PLANNING REPORT

Administrative Review Team

Thursday, October 13, 2022

Shell Station Sign 22-115MPR

Proposed Sign Face Replacement

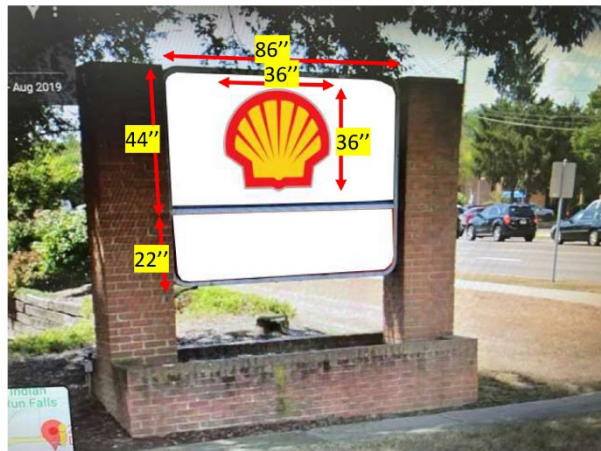
The business identification sign face features no dimensional relief between the logo and the background. Consistent with the recommendations of the BSD Sign Guidelines, the sign face should be extruded to create depth and dimensionality between the logo and the background. The proposed white sign background creates a stark visual contrast between the logo colors and the existing brick of the sign base. The white background should be revised to a light grey or silver color to better complement the brick base.

The entire upper portion of the proposed sign face is to be internally illuminated by LEDs. All areas of the sign faces except for the Shell logo should be made to be opaque as recommended by the Design Guidelines to result in only the logo being illuminated by the internal LEDs at night.

- 1) That the upper sign faces be revised to an extruded polycarbonate design that creates depth to the Shell logo by projecting this element beyond the sign face and that the sign face be revised to provide opacity resulting in illumination of only the Shell logo at night, subject to Planning approval;

- 2) That the sign faces be revised to a light grey or silver color complementary to the sign cabinet and brick, subject to Planning approval;
- 3) That additional details of the proposed changeable copy portion of the sign, including letter/number heights, colors, and fonts be provided for Planning review and approval.
